Access Compliance Report

Public Rights-of-Way

(Curb Ramps)

Intersection ID: 42367	Main Street: FALCONCREST_DR	Cross Street: KESTRAL_RIDGE_DR	Location: W
ADA ID: 9B83D91EF585	Ramp Type: PerpDiag	Initial Pass/Fail: Fail	Overall Compliance: No
Severity Score: 12.5			
Codes/Mitigation Info/Possible Solution		Field Measurements/Component Compliance

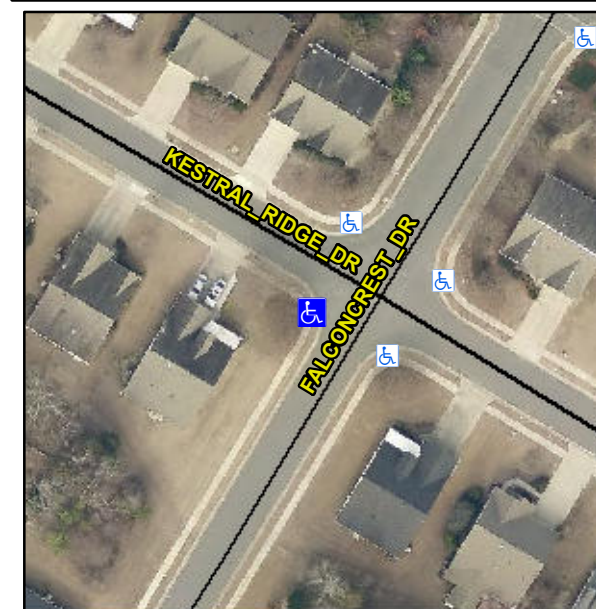
Not Found, R304.2.2

Compliance	Description	Data	Compliance	Description	Data
N/A	Ramp Length (in)	45.0	No	Ramp Slope (%)	8.6
Yes	Ramp Width (in)	51.0	Yes	Ramp XSlope (%)	0.0
N/A	Flare Type LT	N/A	N/A	Flare Type RT	N/A
N/A	Flare Slope LT (%)	N/A	N/A	Flare Slope RT (%)	N/A
N/A	Flare Traversable LT?	N/A	N/A	Flare Traversable RT?	N/A
N/A	Landing Length (in)	N/A	N/A	DWS Provided?	N/A
N/A	Landing Width (in)	N/A	N/A	DWS Contrast?	N/A
N/A	Landing Slope (%)	N/A	N/A	DWS Length (in)	N/A
N/A	Landing X Slope (%)	N/A	N/A	DWS Full Width?	N/A
N/A	Landing Curb? (Y/N)	N/A	N/A	DWS Offset (in)	N/A
N/A	Shared Landing?	N/A			
N/A	Gutter Ponding?	N/A	N/A	Gutter Slope (%)	N/A
N/A	Gutter Lip Ht (in)	N/A	N/A	Gutter X Slope (%)	N/A
N/A	Painted X Walk1?	No	N/A	Painted X Walk2?	No
	X Walk 1 Direction	To SE		X Walk 2 Direction	To NE
N/A	X Walk 1 Width (in)	N/A	N/A	X Walk 2 Width (in)	N/A
	X Walk 1 Slope (%)	0.7		X Walk 2 Slope (%)	2.4
	X Walk 1 X Slope (%)	0.4		X Walk 2 X Slope (%)	3.6

Remove & Replace Curb Ramp With Two New Directional Ramps or Equivalent.
